# **Comments on Cylinder simulation and map making paper**

R. Ansari - 30 May 2022

## A simulation of calibration and map-making errors of the Tianlai cylinder pathfinder array

Fig. 11: The reconstructed map with threshold  $\epsilon = 10^{-3}$  (Left) and  $10^{-5}$  (Right).

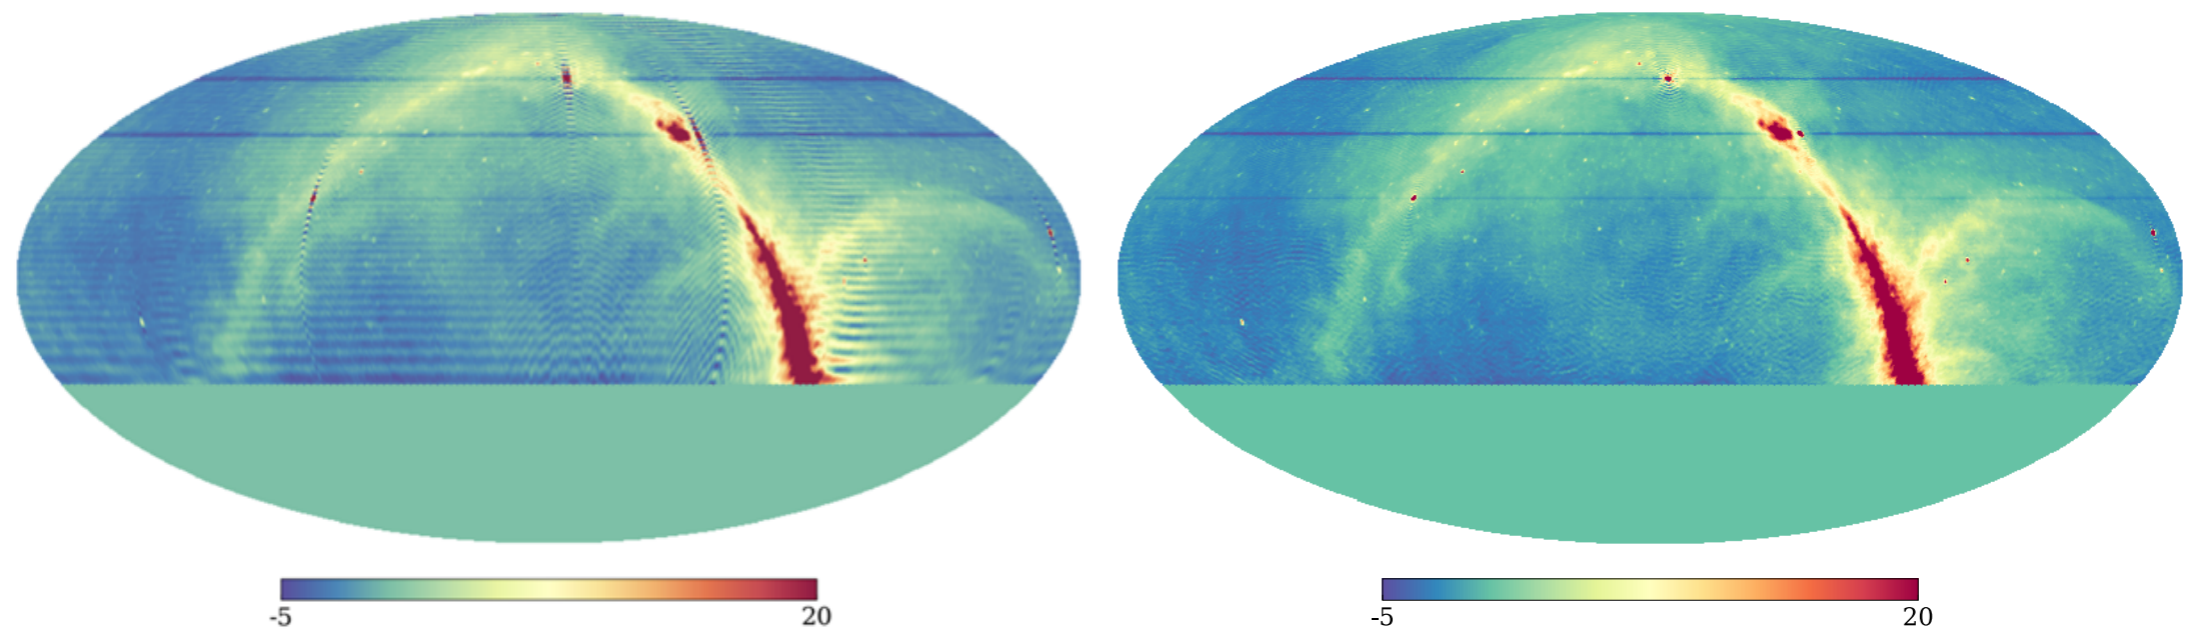
- Use of Moore-Penrose pseudo-inverse generates striping (or wiggles) along the theta direction.
- This is due to sharp cuts along the  $\ell$  direction in the  $(\ell, m)$  spherical harmonics coefficients plane, introduced by the threshold in eigenvalues when applying the Moore-Penrose
- To overcome (partially) this, additional filter in  $(\ell, m)$  plane where applied in J.Zhang et al. papers (2016)
- Another possible way to reduce this effect is to transform the sharp threshold into a smooth threshold
- It is useful to revisit the 2016 papers :  $(\ell, m)$  filter, R-response matrix and filtering using the error covariance matrix, and compute the corresponding quantities to get a better explanation and understanding of these effects for this paper
- Note also that the noise covar. Matrix should be taken into account in the Moore-Penrose pseudo-inverse expression.

$$\left[\widehat{\mathcal{I}}(\ell)\right]_m = \mathbf{H}_m \left[\tilde{\mathcal{V}}\right]_m \quad \widehat{\mathcal{I}}_m = (\mathbf{L}_m^\dagger \mathbf{N}_m^{-1} \mathbf{L}_m)^{-1} \mathbf{L}_m^\dagger \mathbf{N}_m^{-1} \mathcal{V}_m \equiv \mathbf{H}_m \mathcal{V}_m \quad \text{Diagonal noise matrix} \quad \mathbf{H}_m = \left(\mathbf{N}_m^{-\frac{1}{2}} \mathbf{L}_m\right)^{-1} \mathbf{N}_m^{-\frac{1}{2}}$$

Figure 4.4.3: Comparison of the R matrix for regular 1(left) and regular2 (right) configurations.

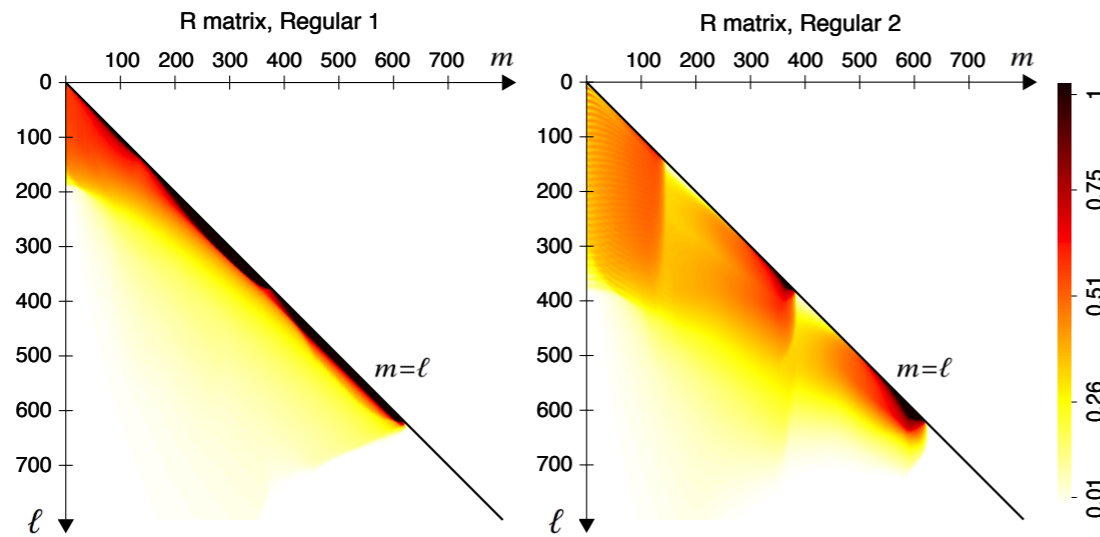
Notice the limited ell range at low m  
This is where the pseudo-inverse threshold has the largest impact, hence the striping
